TOWN OF HORIZON CITY
Planning and Zoning Commission Staff Report

Case No.: SDF25-0001 Verdancia Unit 1 Final

Application Type: Final Plat
P&Z Hearing Date: April 21, 2025
Staff Contact: Art Rubio
915-852-1046 Ext. 407; arubio@horizongcity.org
Address/Location: North of Eastlake Blvd. and East of Desert Spring Dr.
Nearest Park: Horizon Mesa Park
Nearest School: Desert Hills Elementary, Horizon Middle School and Horizon High School

Attachment 5: Final Plat North

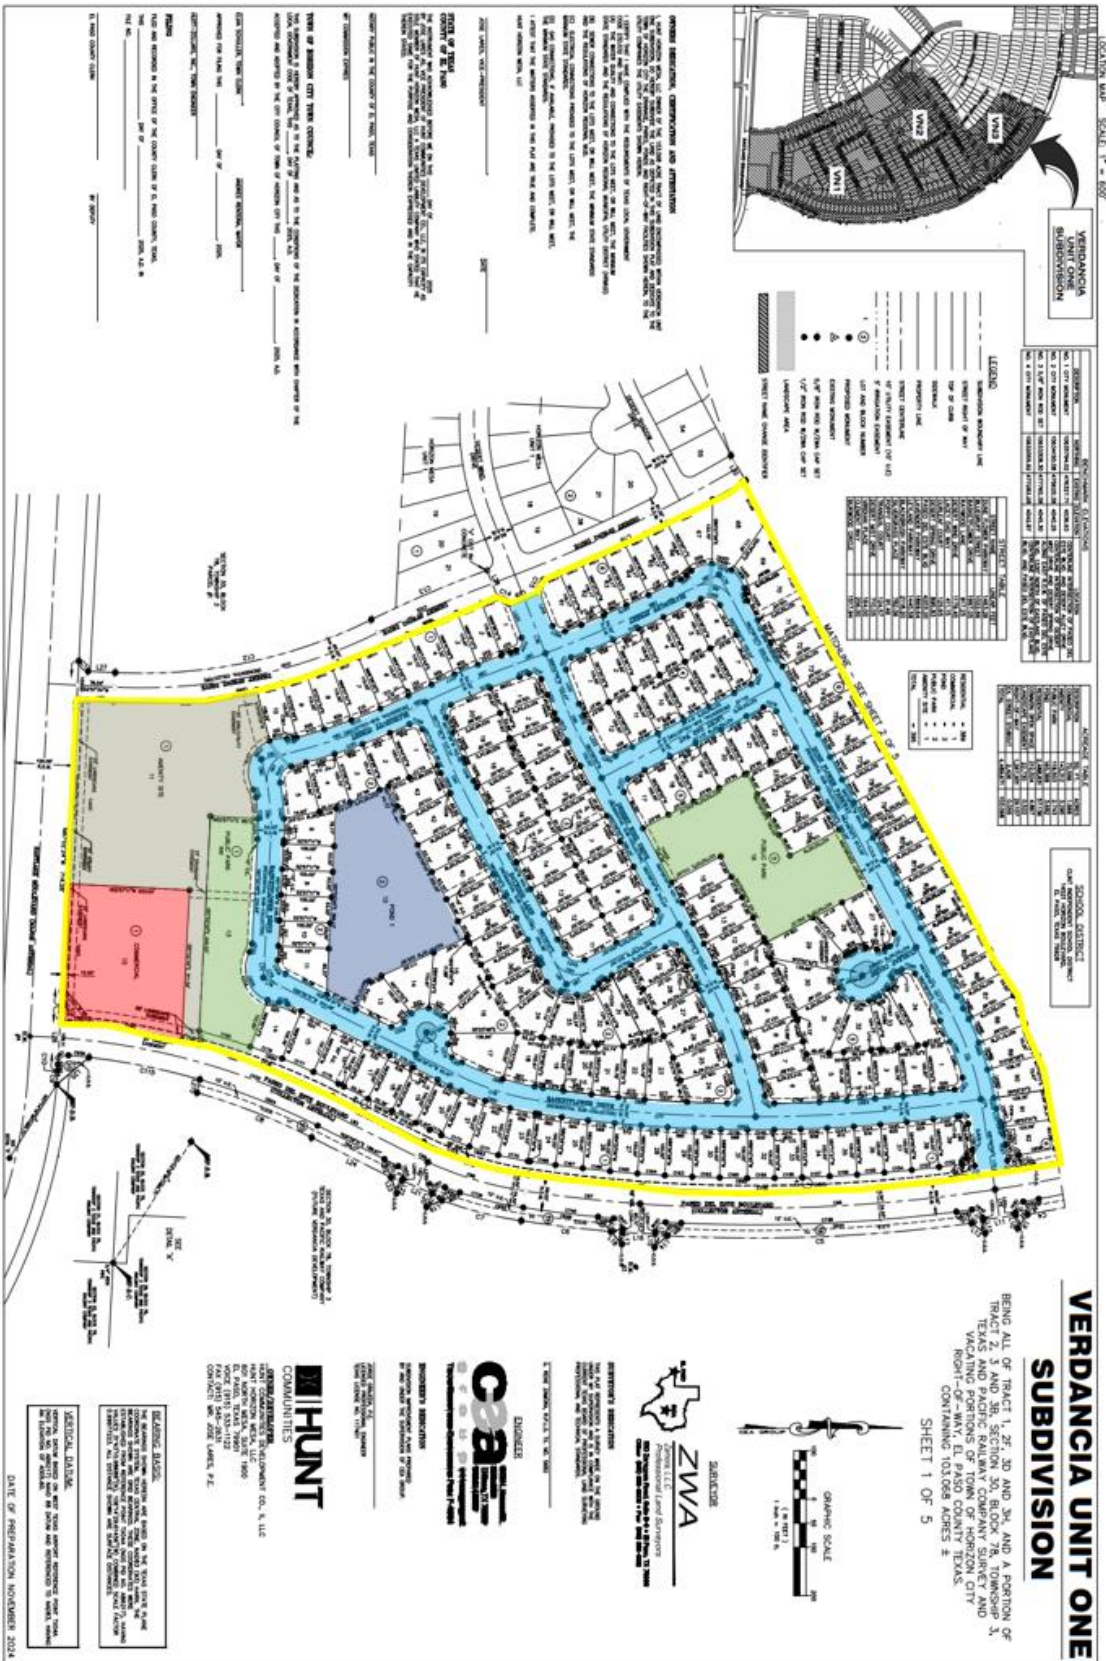
A modification letter from CEA dated August 21, 2024 requested a variance for a proposed 53.5' cul-de-sac. This cul-de-sac was not located in the Final Plat however a 48.50' cul-de-sac is shown. Please provide proof of approval for this variance on Curleaf Court with radio of 48.50'.

Lot 16, Block 1; label DE and Utility Easement as well, Proposed wastewater line goes through the easement.
